12 May 2016 - Extract from Consultation meeting notes between Jacobs and the Cawdor Maintenance Trust.

Subject: A96 Inverness to Nairn - Cawdor Maintenance Trust drawings (PE: 0159)

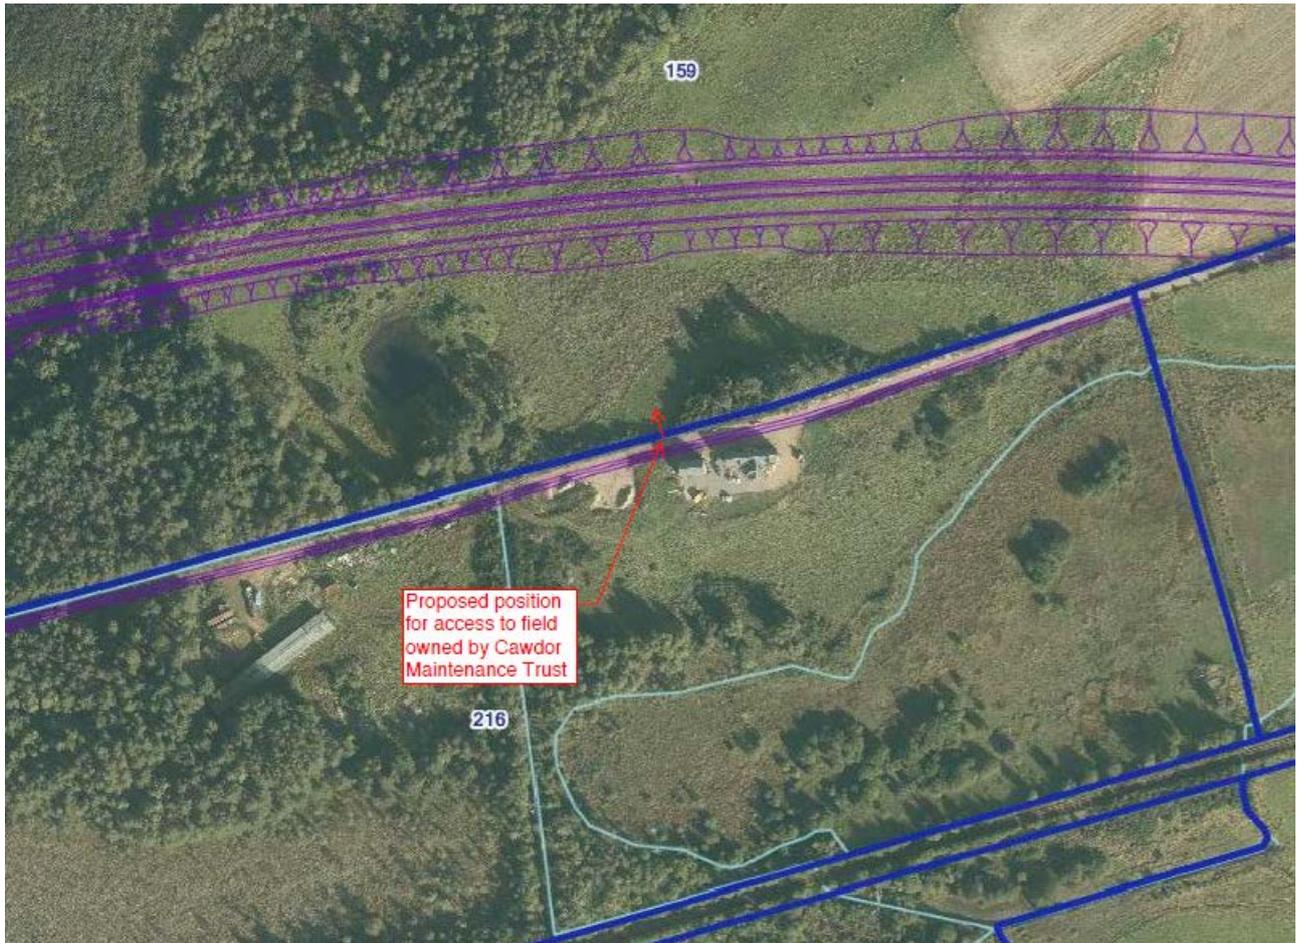
- I've reviewed potential access locations for the land owned by Cawdor Maintenance Trust immediately north of North Kildrummie Farm. See attached for suggest location. It would be much appreciated if you could review this position and confirm if this is likely to be acceptable.
